KARACHI MUNICIPAL CORPORATION.

Reference No. B. S. P. 588/38

PROPOSED BUILDING ON PLOT NO. 44, - M.M-4.

Case No. B. S. P. 588/38.Re:—Plot No. 44 Sheet No. 42-4, in main Qr.

SITE PLAN

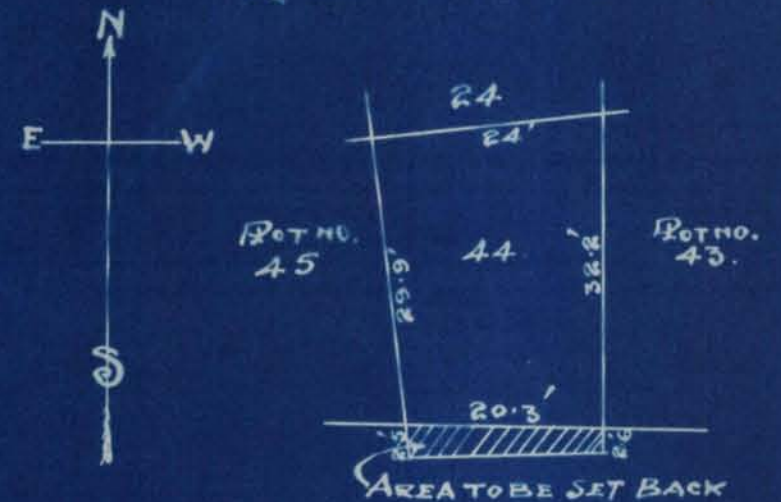
No objection to the site plan
